Environmental Review Team Report

Park Place Subdivision Colchester, Connecticut

December 1980

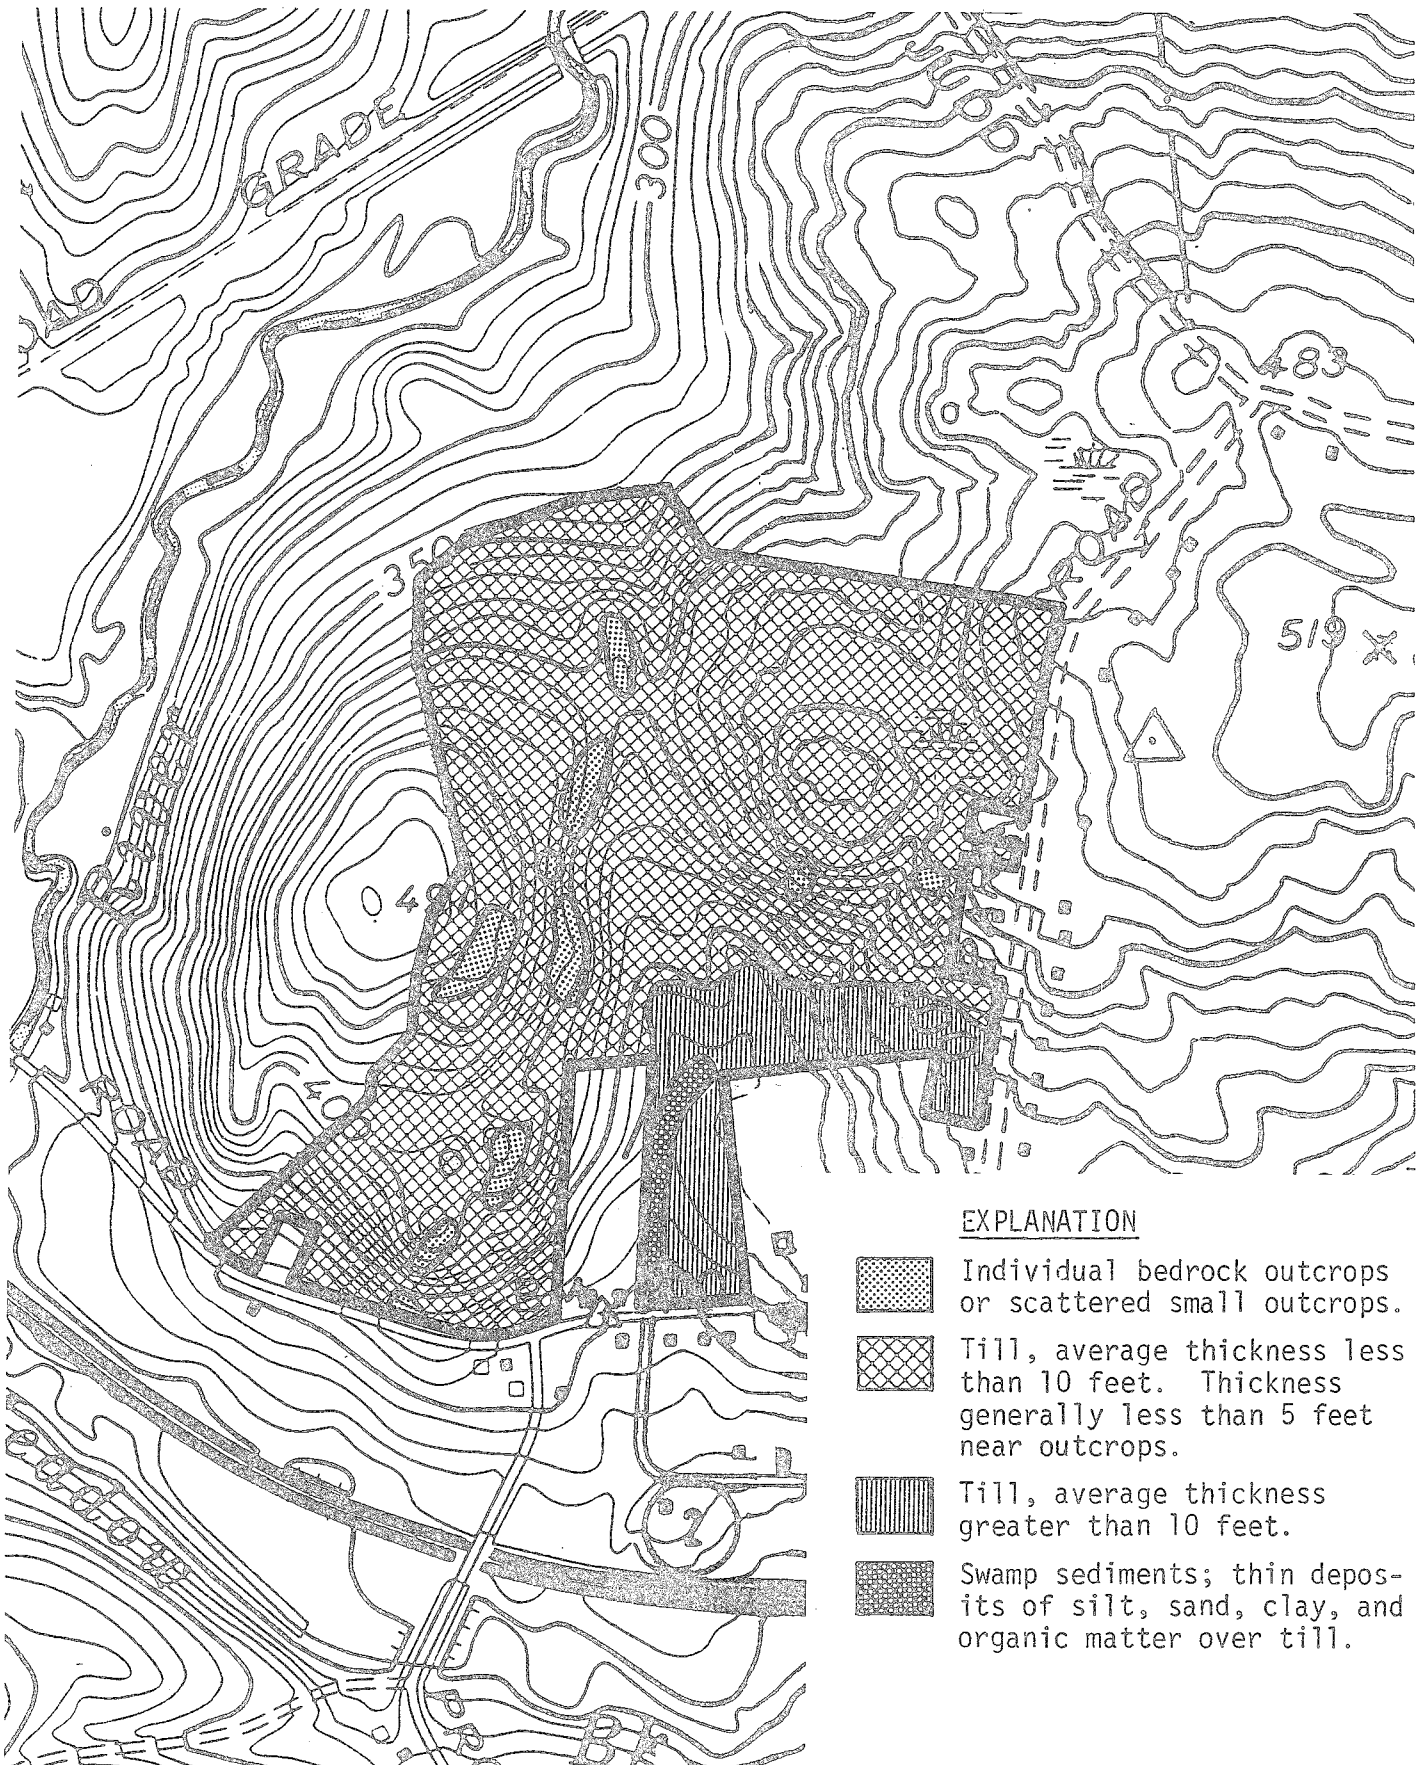
Roads planned for this development should be carefully examined, in some cases the slope of these roads exceeds the 8% maximum slope allowed in the Subdivision Regulations.

Section 6.3.6 of the Colchester subdivision regulations limits dead end streets to 600 feet. As shown on the plan, the dead-end road is over twice this length. If under Section 6.3.6 this dead-end street is to be extended in the future, then it will have to be built to local street standards.

Section 6.3.7 of the subdivision regulations limits street grades to 8%. In several cases the proposed roads exceed this slope, Relocation of the roads could avoid some of these slopes, although the hilly nature of the site makes this difficult and would probably reduce the total number of lots.
